RAM AIRCRAFT, L.P.
SERVICE BULLETIN

SB2019-01

SUBJECT: Hardware installation at upper forward-most bolt boss on RAM FAA-PMA crankcases

PURPOSE: To assure proper crankcase bolt grip

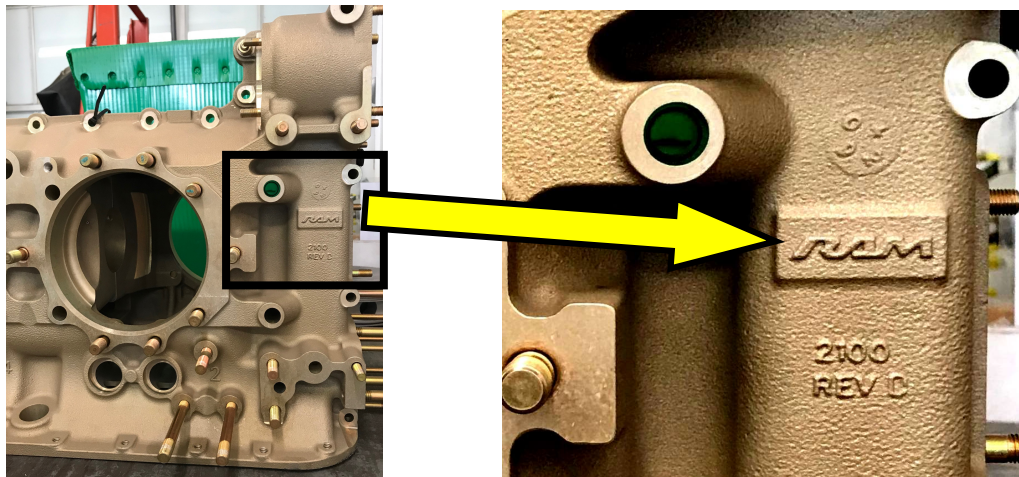
Thirty-six (36) specific crankcase serial numbers (listed above) were manufactured by RAM Aircraft, LP (RAM) in 2019 under part number 2097-2 (left half only) with excess material removed by spot face machining at the upper-and-forward-most bolt boss only. No other bolt boss locations are affected. Engine overhaul facilities and engine installation mechanics need to be aware of this anomaly when installing hardware at this bolt boss location. For serial number identification, refer to Section B.

FIGURE 3
Upper-Forward-Most Bolt Boss Measurement

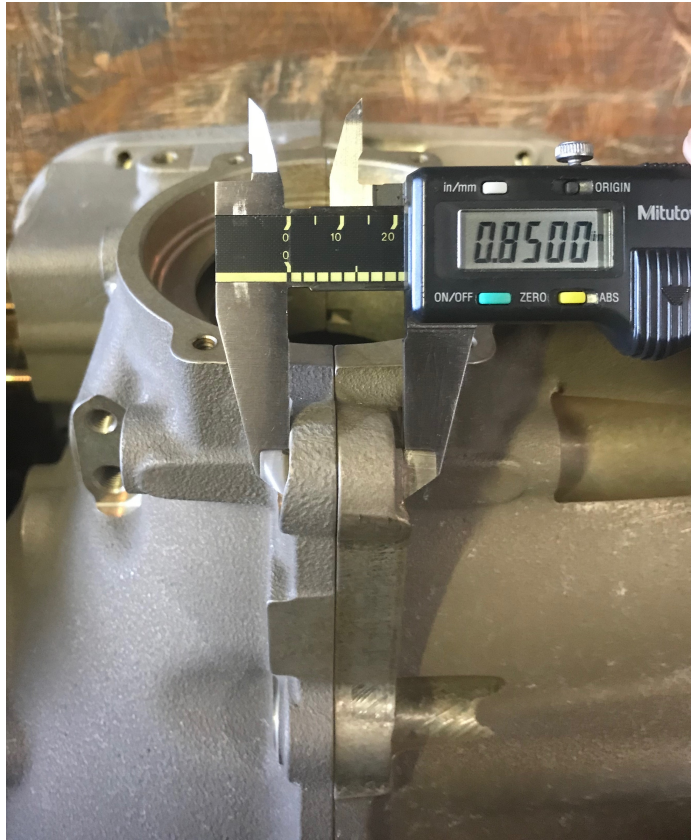
Inspect left and right crankcase mating halves at upper-forward-most bolt boss. With crankcase halves mated together, measure across both halves at the bolt boss. The boss material thickness should be generally 1.0 inches. Each half should have equivalent thickness (approximately 0.5 inch each half). Mis-machined bosses will be evident as the overall total width is approximately 0.85 inches in lieu of the standard 1.00-inch width. See Figure 3.

If total measurement across the Left and Right halves measures 1.00 inches (+/- .05 inch) no further action is required. Use standard hardware as specified in the applicable service manual or overhaul manual.

If total measurement is less than 0.95 inches, refer to Section “D” for corrective action.

FIGURE 3
De-ice Brush Block Bracket and Spacer Installation

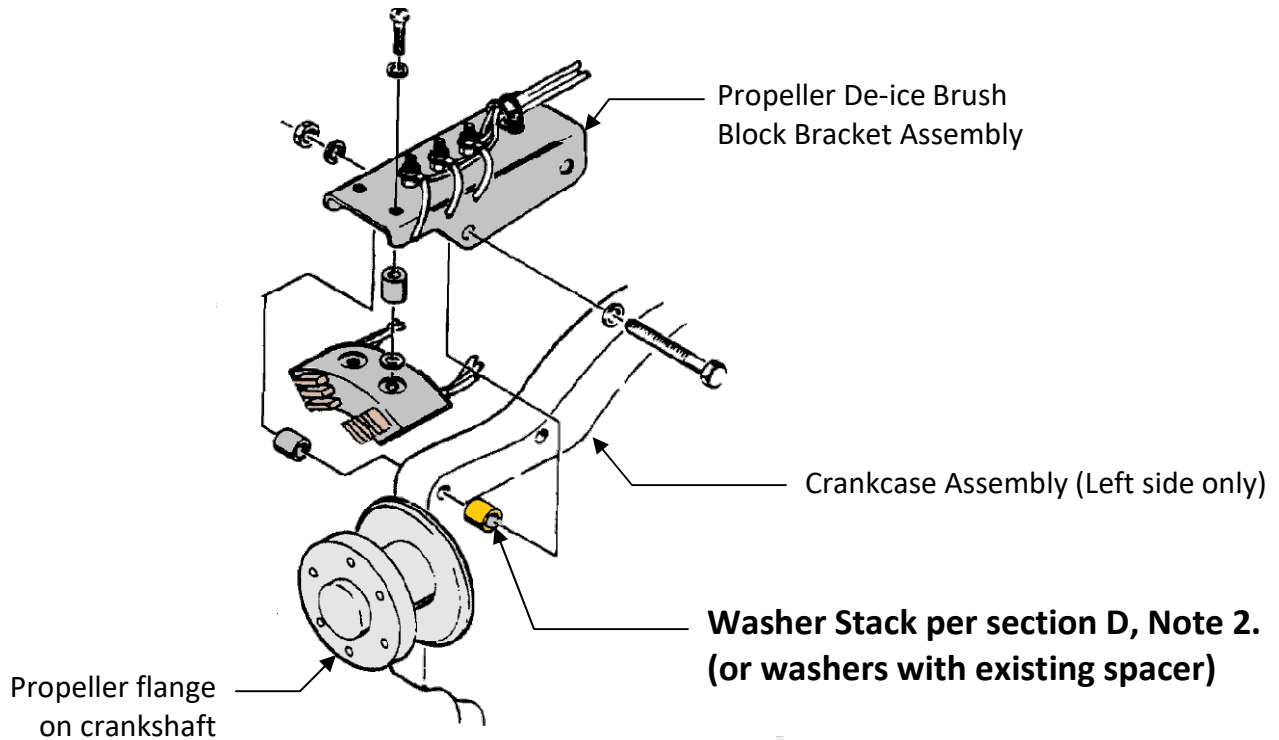
1. For affected engines installed without electro-thermal propeller de-ice systems, the bolt installed in the upper forward-most bolt boss (See figure 1), will need to be shorter than the standard bolt. Use bolt part number AN5-11A in lieu of the specified AN5-13A bolt in this location only. Alternatively, it is acceptable to use AN5-12A bolt with no more than two extra p/n AN960-516 washers to ensure that the nut may be properly tightened to required torque value with no possibility of bottoming on the bolt shank.
2. For affected engines installed with electro-thermal propeller de-ice brush block bracket assembly, it is acceptable to install a stack-up of washers (or a combination of washers and the standard spacer) between the crankcase boss and the bracket. Select the number of washers, p/n AN960-516 or AN960-516L as required to fill the space.
